TECHNICAL RELEASE 60, REVISED OCTOBER 1985
210-VI
AMENDMENT 1

SUBJECT: ENG - EARTH DAMS AND RESERVOIRS

Purpose. To eliminate the parameter H and redefine the parameters L, T, and H_w in the peak breach discharge criteria; to define the hydrologic boundaries for areas 1, 2, and 3 on page 2-10; and to update the requirements for the design of diaphragms used in piping and seepage control.

FIGURE 2-1 (A)
100-YEAR, 10-DAY RUNOFF (INCHES)
PRINCIPAL SPILLWAY HYDROGRAPH

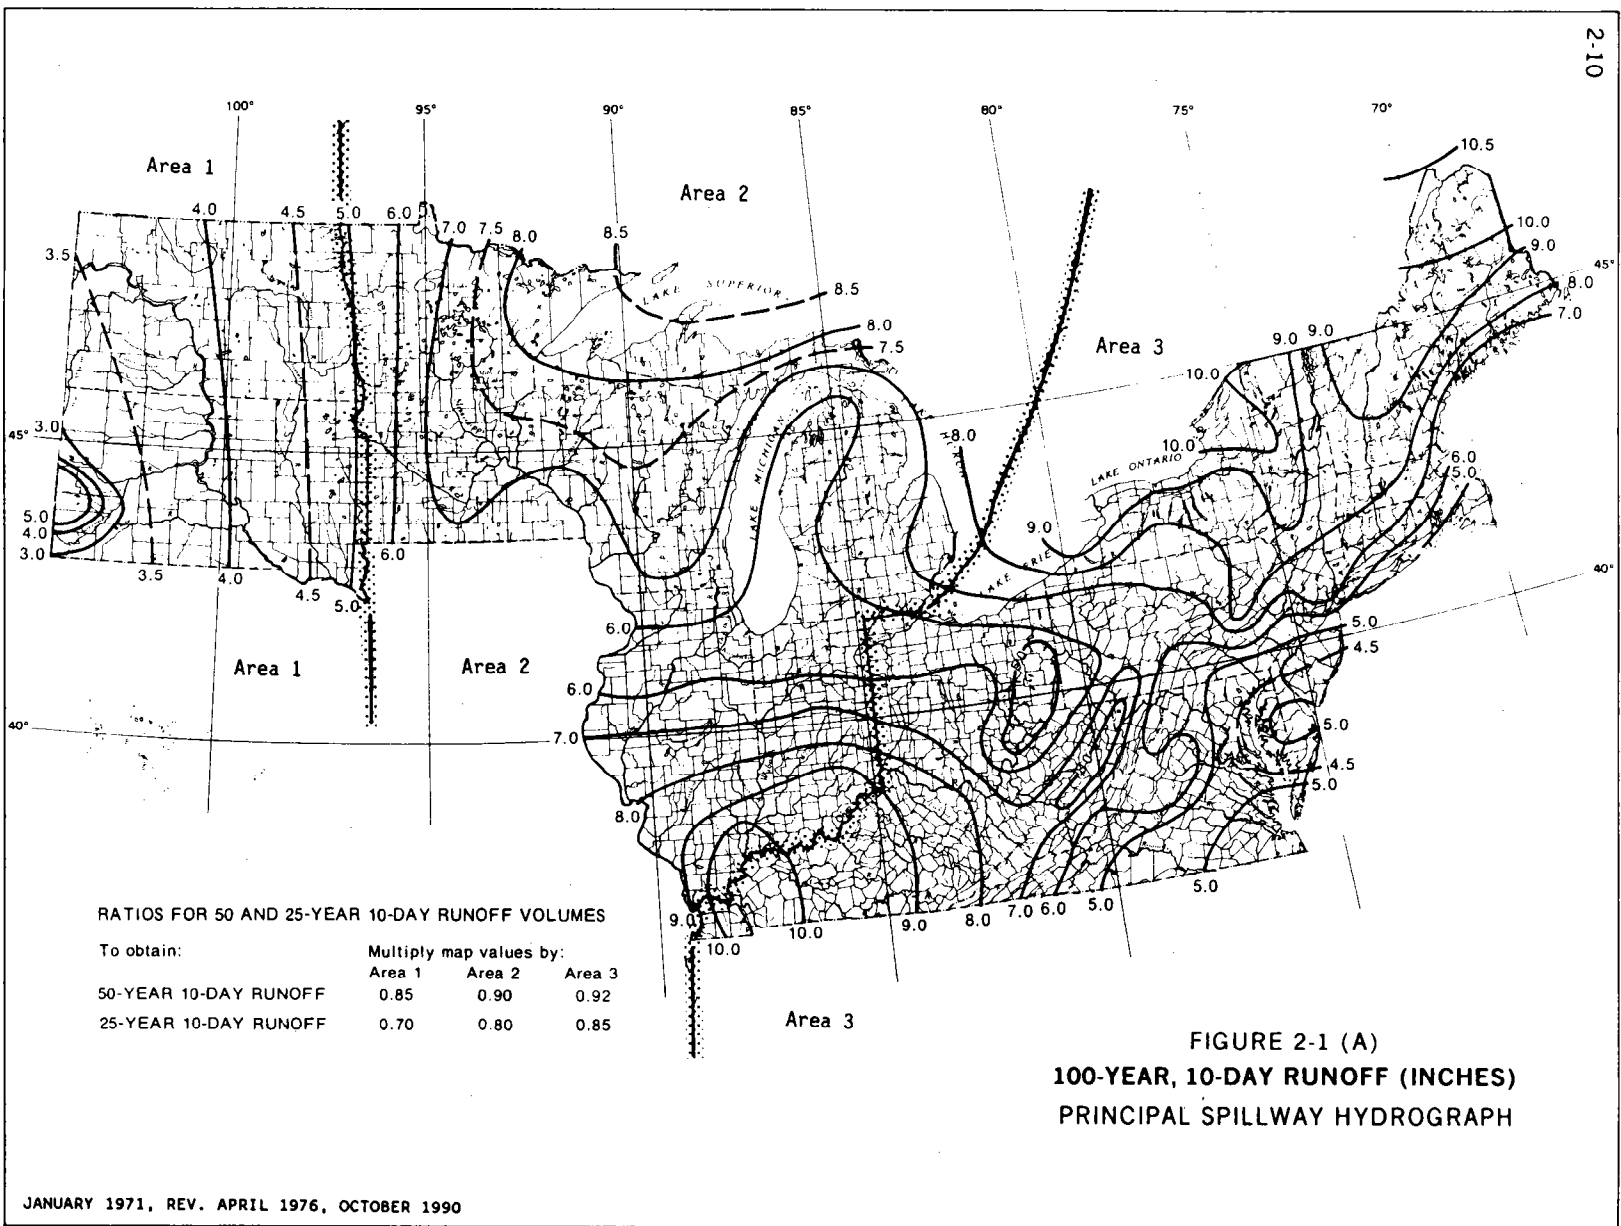
The 100-year, 10-day runoff map on page 2-10 should be divided into three areas, i.e., areas 1, 2, and 3; but the hydrologic boundaries and the area numbers were not shown. The revised page shows distinct boundary lines and area numbers to delineate and identify the areas.
